Development Permit 164-19 – New Commercial Building (Child Care Facility & Retail Store)

This Development Permit application is for the development of a Child Care Facility and Retail Store (New Commercial Building) and associated signage at 55 Riverside Gate. As the land use designation is Direct Control (DC) District (Amending Bylaw 35-00), Council is the Development Authority responsible for making a decision on this development permit application.

North Elevation (Building Frontage)

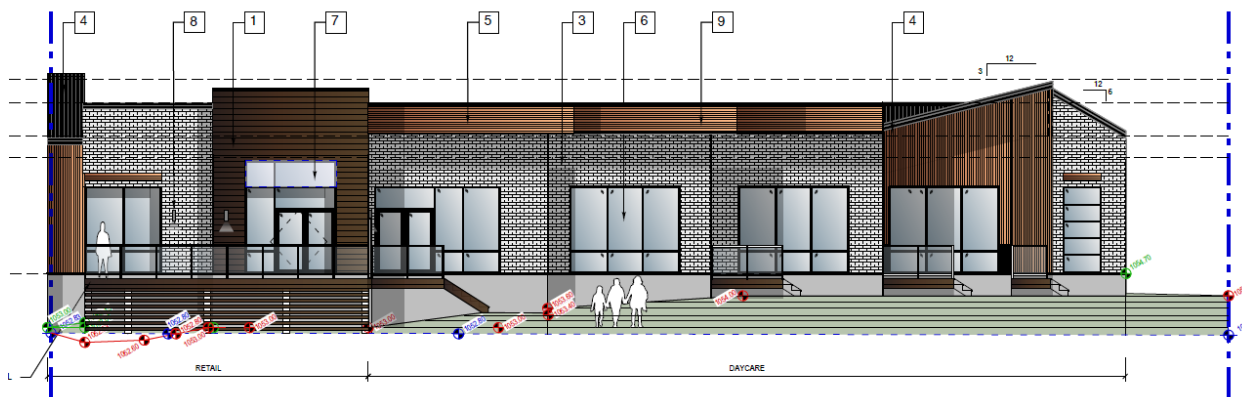
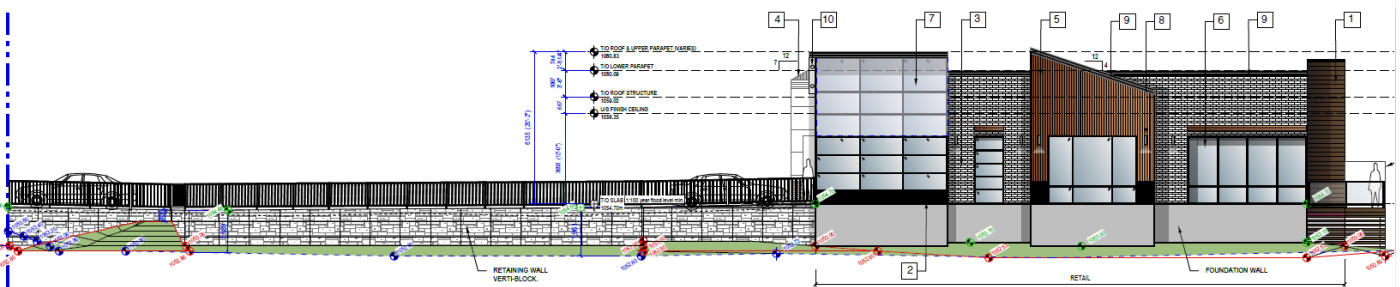
d. No signage interfacing with the river valley on the south, west or east elevations shall be illuminated;

Signage is only proposed on the north (frontage) and east elevations of the building. The proposed fascia signage on the north frontage (two signs) covers 8.54% of the building façade which does not exceed the maximum requirements outlined in the Land Use Bylaw. The east elevation proposes a sign that covers 7.62% of the building façade. As per Administration’s request, there is no signage proposed on the west elevation to maintain the character of the river valley. All of the signage is non-illuminated and mounted directly on a flat panel frame to be mounted to the wall.

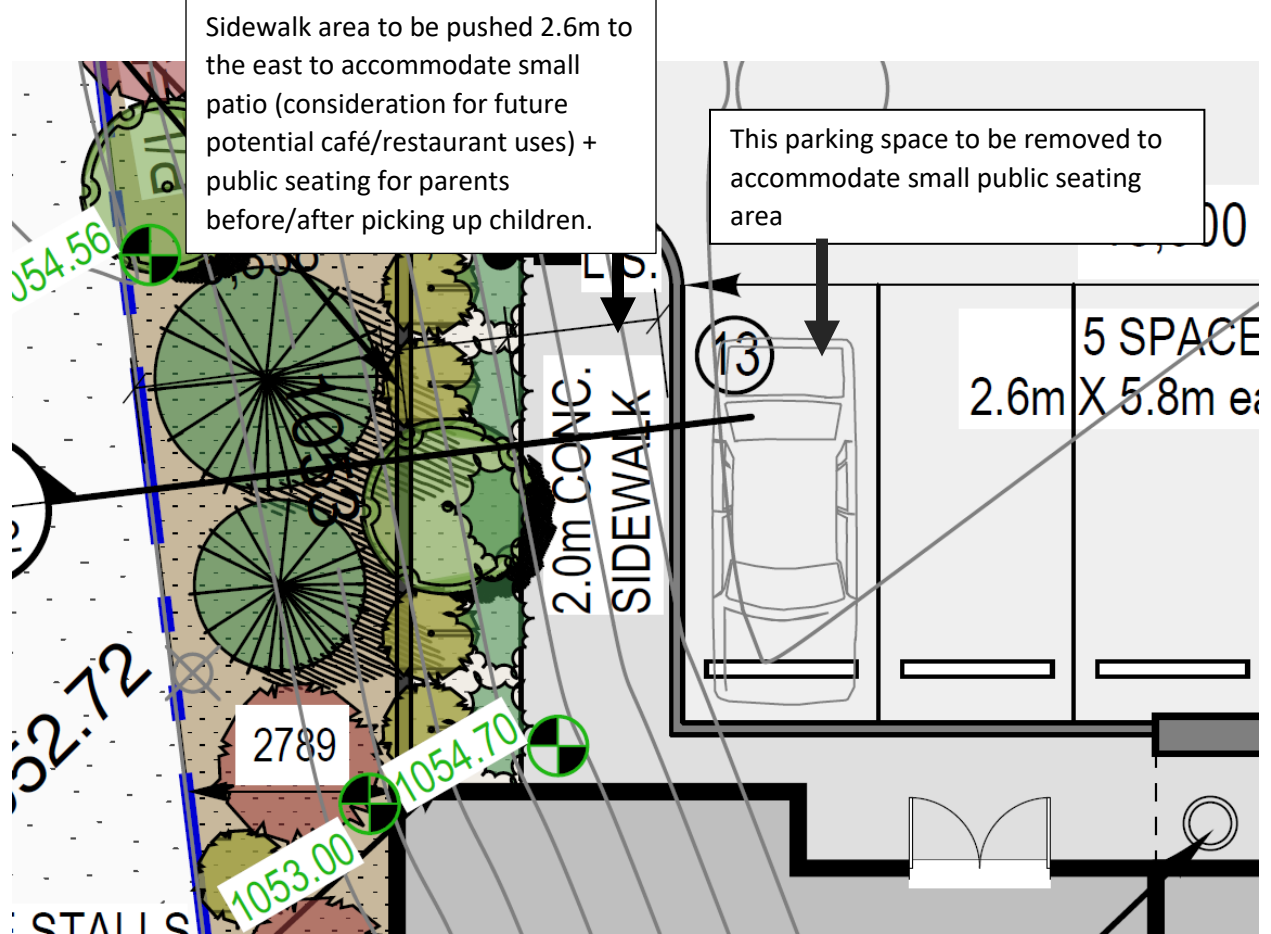
1. Prior to the release of the Development Permit, the Developer shall:
 - a. Submit a revised site plan as follows, to the satisfaction of the Town:
 - i. extend the curb beside the sidewalk on the southwest corner of the site 2.5m to the east and remove the parking space affected by this curb movement;

- ii. identify a minimum of (2) two permanent table fixtures at the additional patio location identified in Condition 1a(i);
 - iii. provide the minimum distances from the retaining wall to the planting bed; and

- iv. remove the note on the western edge of the site plan regarding bicycle rack locations that have since been relocated on the plan to the eastern edge of the site.

1. Section 14E.2.2 [Minimum Parking Required] to allow for 29 parking spaces, where the minimum required is 34 parking spaces, a variance of 5 parking spaces.

A variance of five parking spaces is supported by Administration given the proposed uses for the commercial building. With the largest tenant being a child care facility, it will likely be busy at morning and afternoon pick/-up/drop-off times, but largely vacant for the remainder of the day, with the exception of the employee parking. The retail store location will still have available parking and likely be busier in counter-peak times from the child care facility. That said, administration also reviews development applications for new buildings, not just on the current uses, but the range of potential uses that could be located within the building. Based on the active transportation strategy, introduction of Okotoks Transit and the pedestrian connections to this somewhat central site, a small parking variance is supported.
